SUBJECT: Site Plan Review for 88 North Main Street

PC Case No: 2016-14

RE: PC 2016-14: Site Plan review for patio enclosure at 88 North Main Street

**Re:** **Keppers Tavern (Patio Enclosure)**

**REAR ELEVATION**  
S: 1/4" = 1'-0"

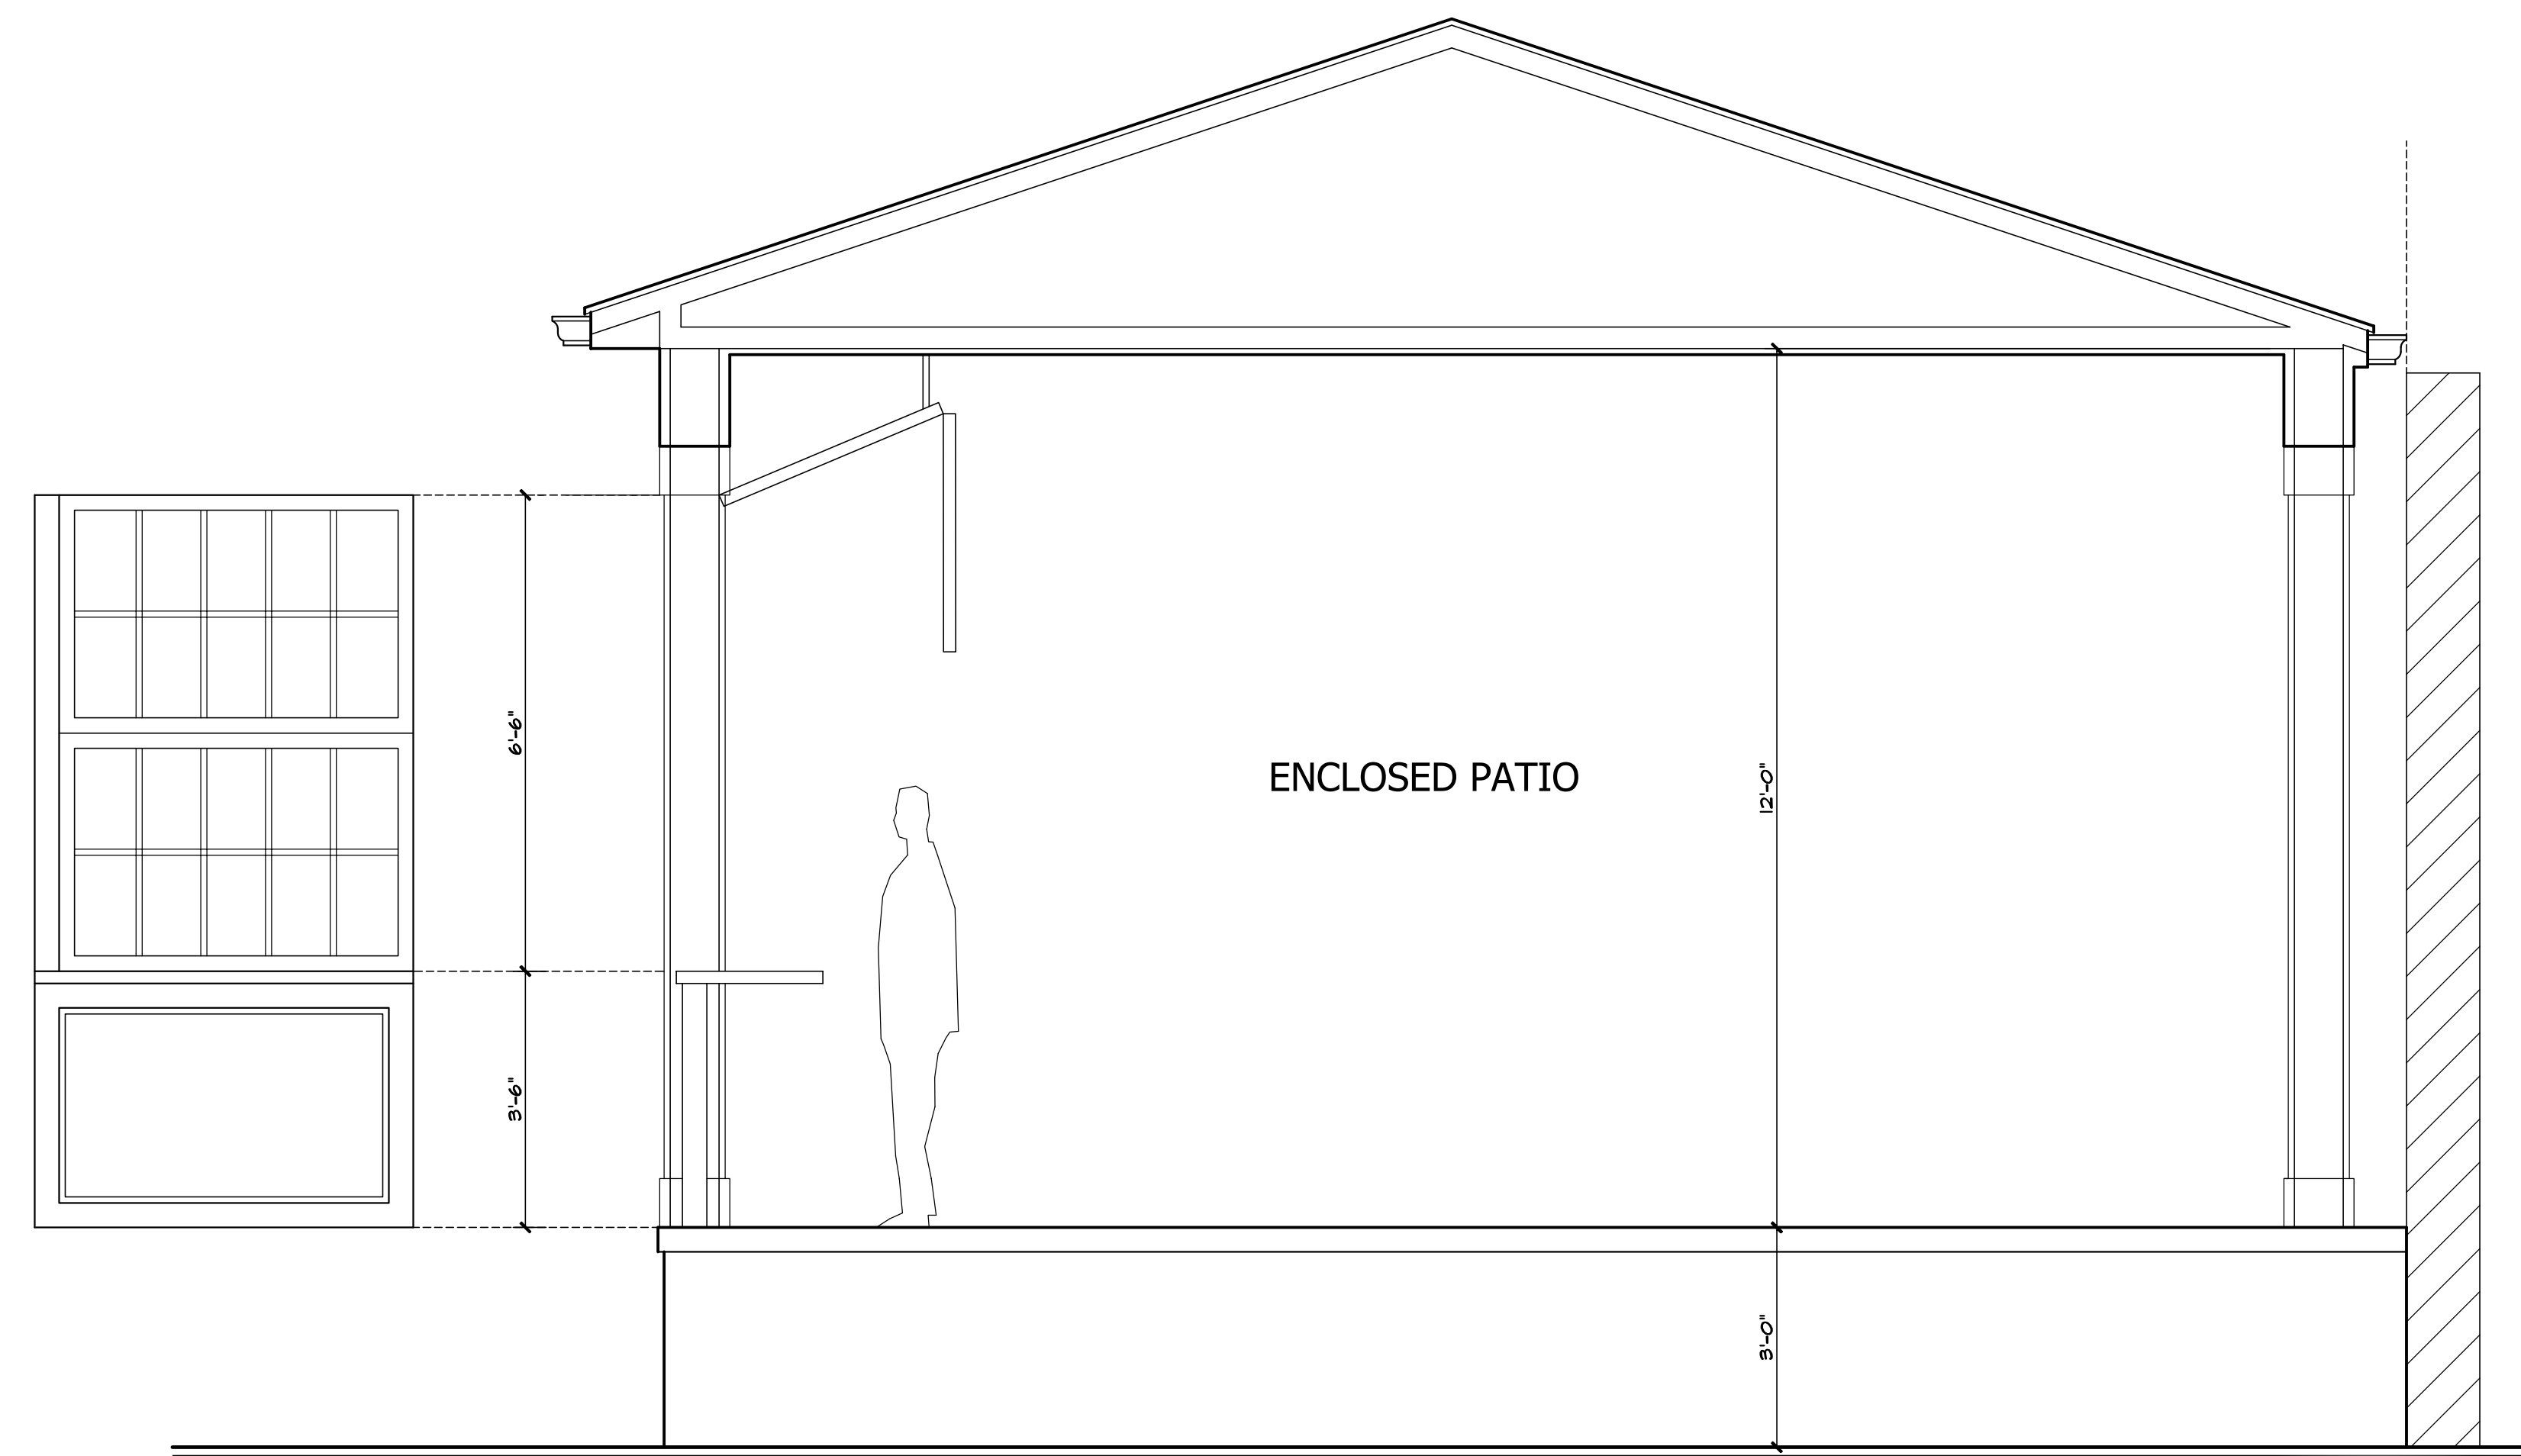
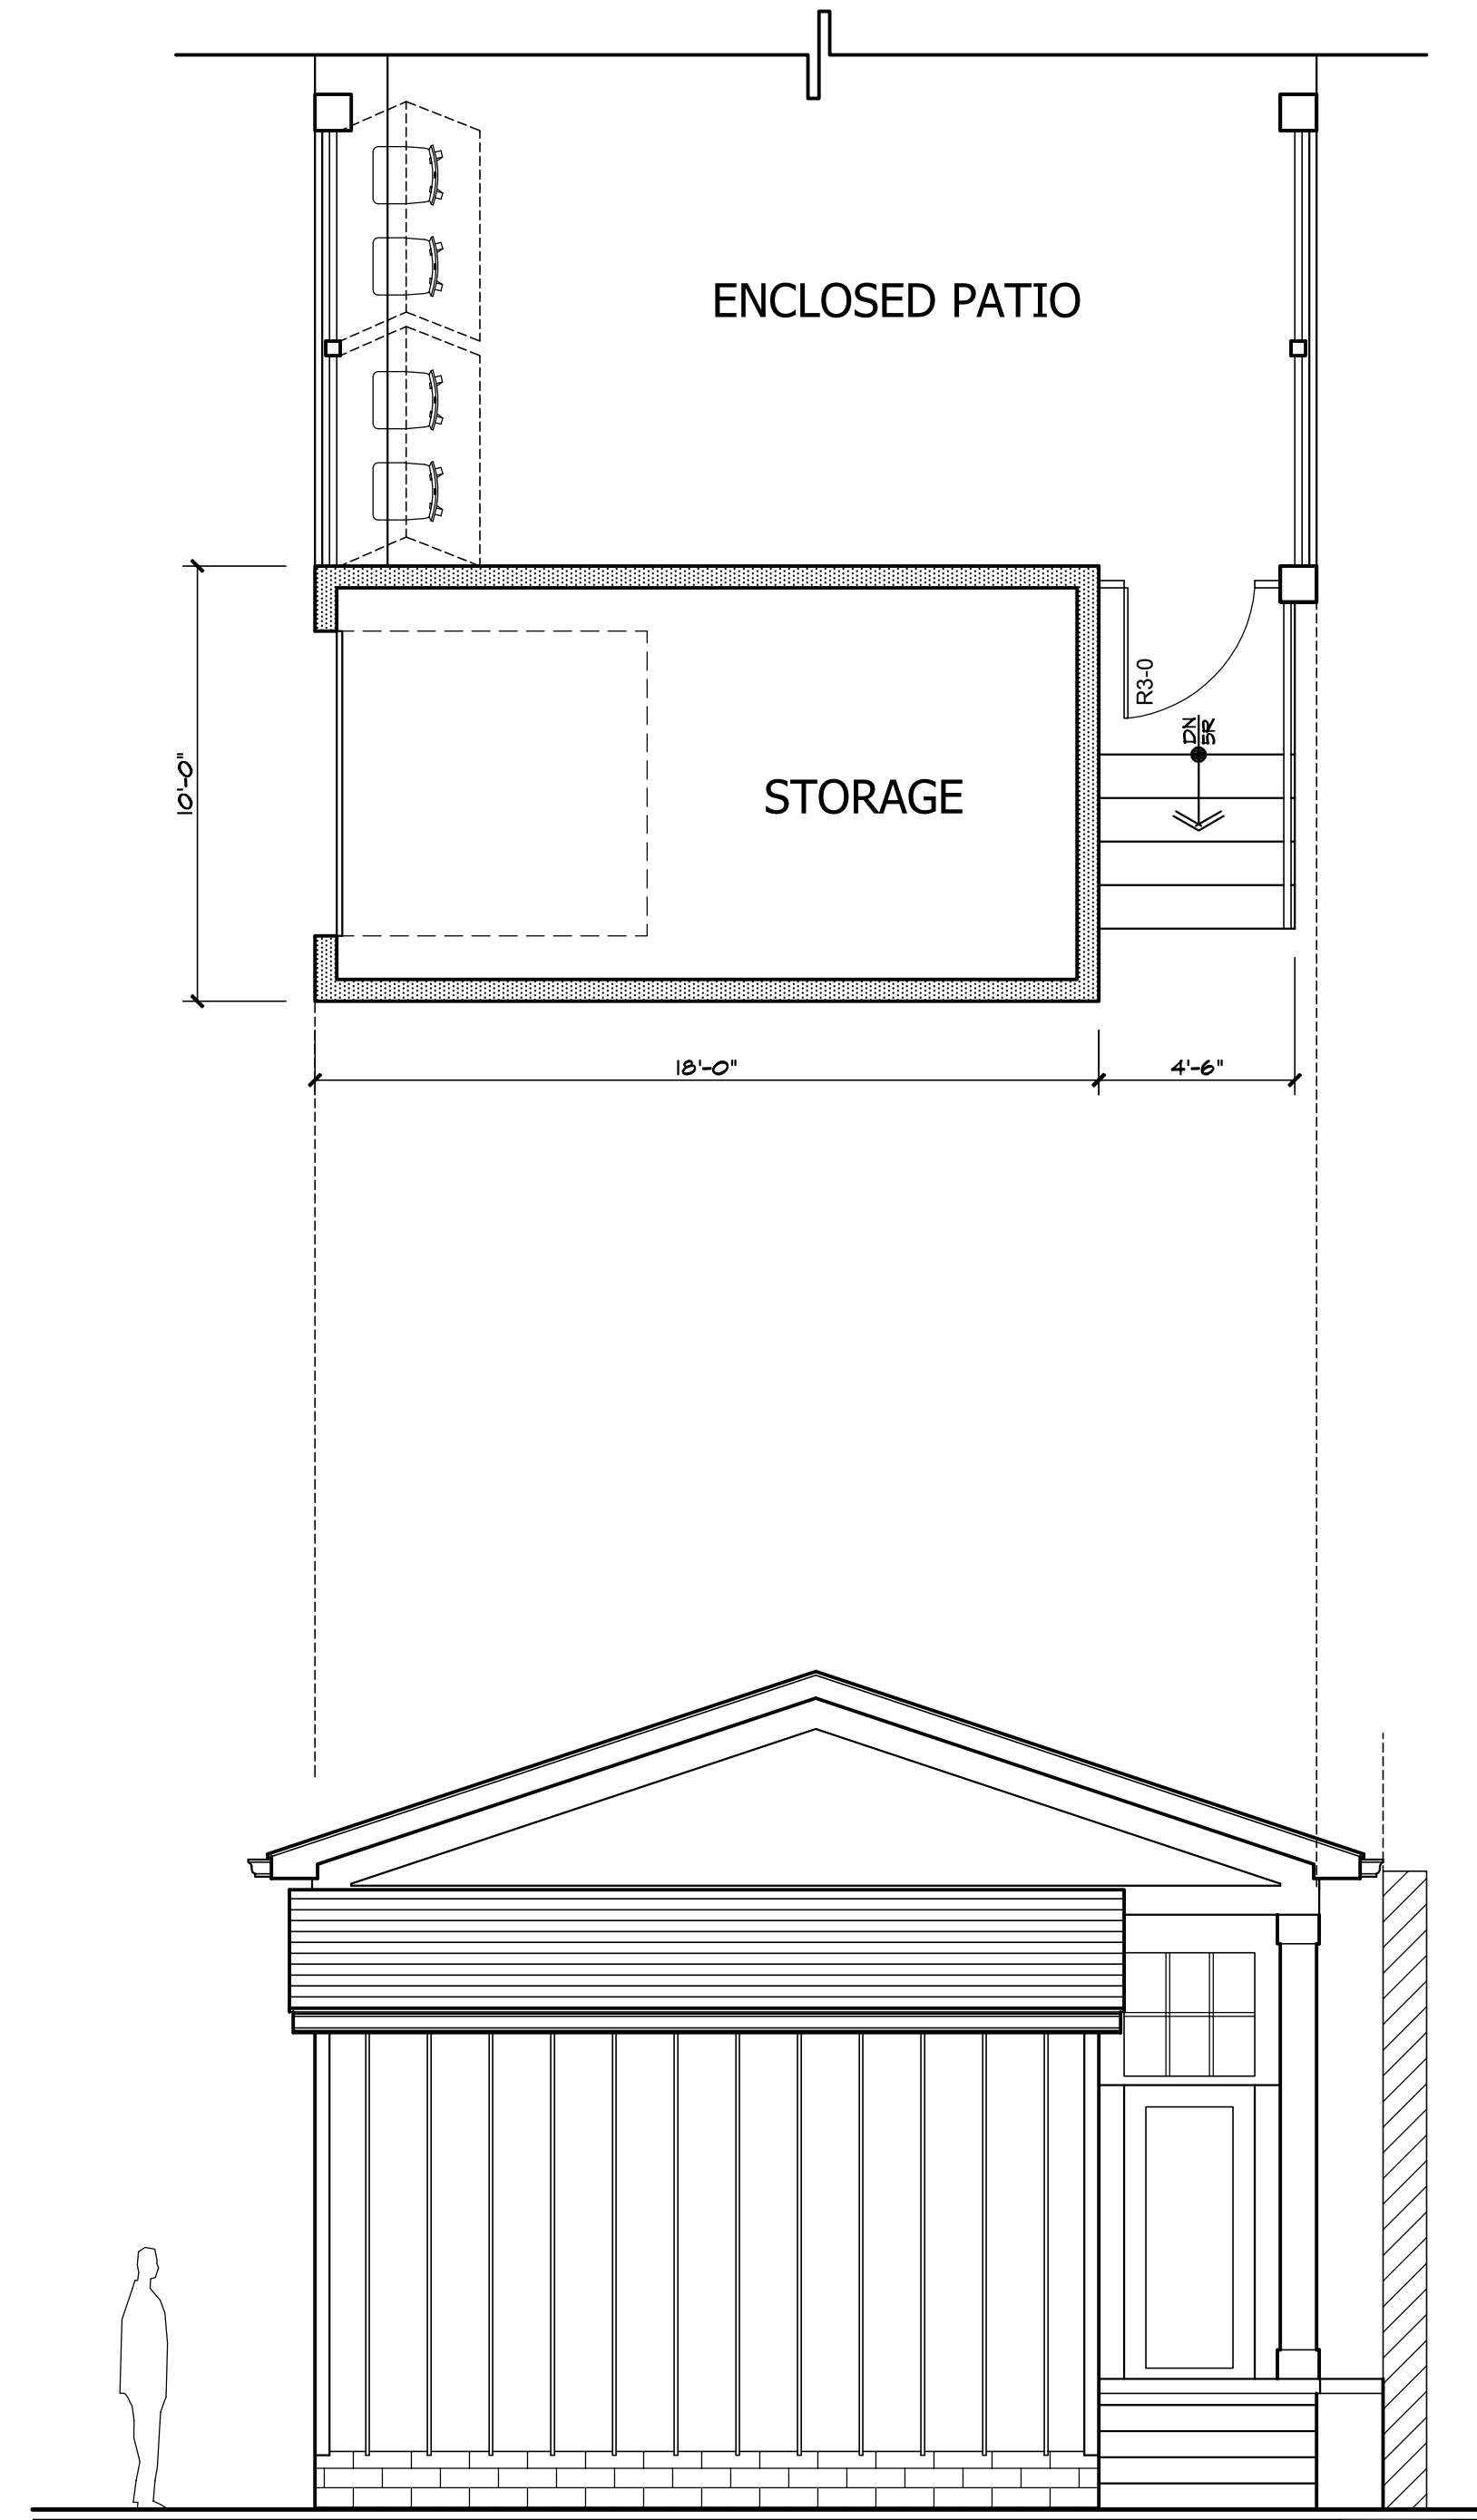
**Structure Height:** The District 5 regulations state no façade or portion of a building shall exceed a height such that it would be visible above the height of the existing facades fronting North Main Street when viewed from the Village Green. The proposed enclosure contains a shallow pitched roof setback 60 feet from the Main Street façade. Staff does not anticipate the improvements would be visible from the Village Green; however, the applicant must submit a sightline study to demonstrate such.

1. Submit a sightline study depicting the roof heights of the existing Main Street façade and the proposed improvements viewed from the Village Green.
2. Subject to the approval of City Engineer Thom Sheridan.
3. Satisfaction of the above conditions prior to scheduling of a preconstruction meeting with City Officials and no construction of any kind shall commence prior to the issuance of a Zoning Certificate.
